Revision	Date	Description	Part reference	Designer	Reviewer & Approval
V3	2014.10.29		PCB:205151G SMT:605951G DIP:605952G	Vic	Eric
V3.1	2015.1.16	Page3 1.Backup battery charger source change to VCC3P3V Page8 1.add up/down test point Page9 1.Net DC_IN&DC_IN_A short 2.VBUS source connect to DC_IN 3.R108 short,不上零件	PCB:205202G	Vic	Eric
V4	2015.3.6	Page4,7 1.add net"IO_BT_CTRL5"&"IO_BT_CTRL6",R199,R200 Page8 1.add charge LED of shutdown 2.add LDO(VLED_3P3V)always turn on Page9 1.Main battery charge current change to 600mA/h	PCB:205225G SMT:606062G DIP:606063G	Vic	Eric
V5	2015.9.2	ADD RTC LOD Power,delet RTC backup battery	PCB:205326G SMT:606323G DIP:606324G	Vic	Eric

MS916 Revision HistorySize
B

MAIN BOARD_MS916_V5_20150902_P/N 205326GRev
5

Title		
Power IN & RTC		
Size	Document Number	Rev
B	MAIN BOARD_MS916_V5_20150902_P/N 205326G	5
Date:	Thursday, September 03, 2015	Sheet 3 of 10

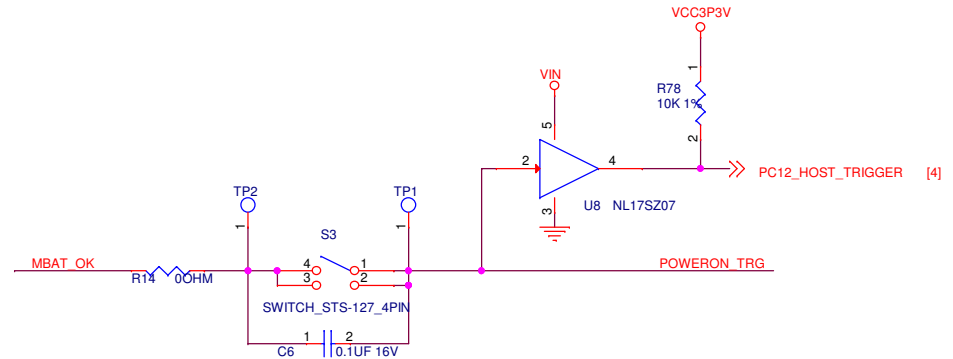
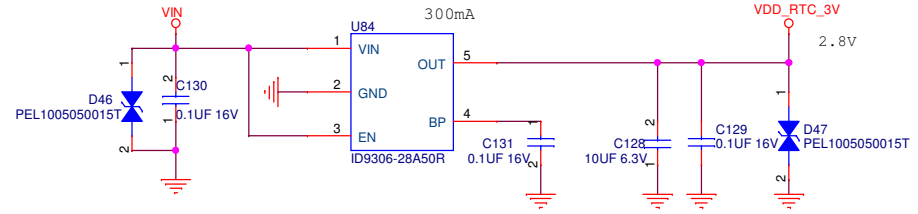
VBAT = 1.8 to 3.6 V: power supply for RTC
RTC耗電實測:1.1uA

C1(Backup battery),R121,D36刪除

RTC LDO : 2.8V

Title			Buzzer & LED & Key	
Size	Document Number	MAIN BOARD_MS916_V5_20150902_P/N 205326G		Rev
B				5
Date:	Wednesday, September 02, 2015	Sheet	8	of 10

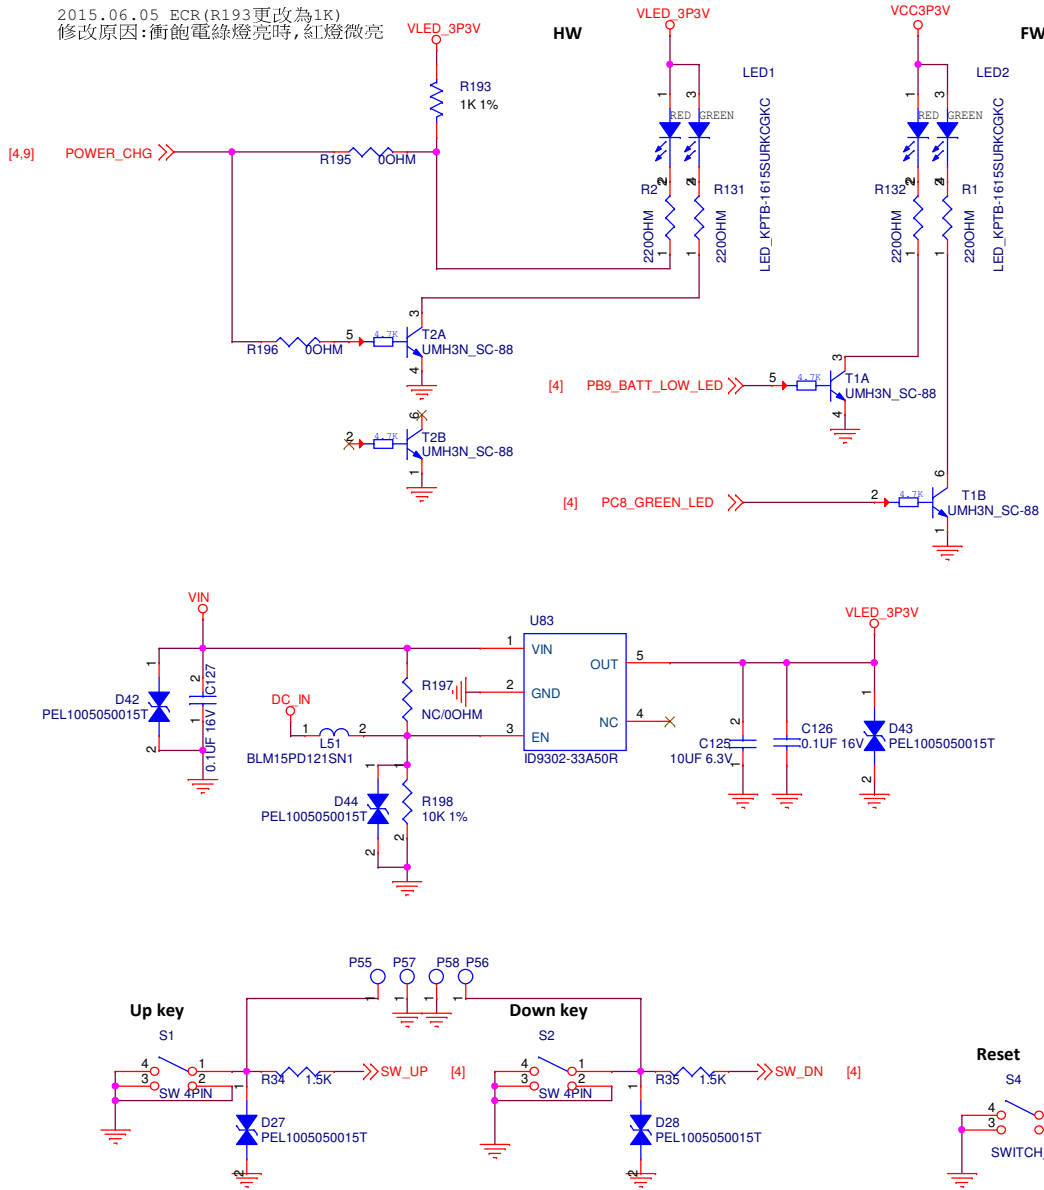
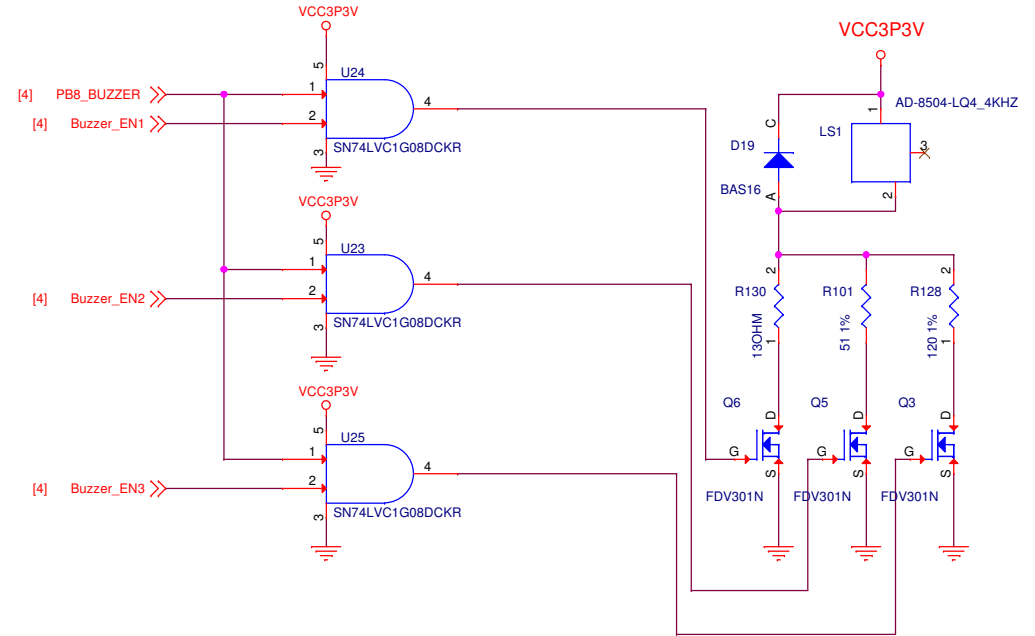
2015.06.05 ECR(R193更改為1K)
修改原因:衝飽電綠燈亮時,紅燈微亮
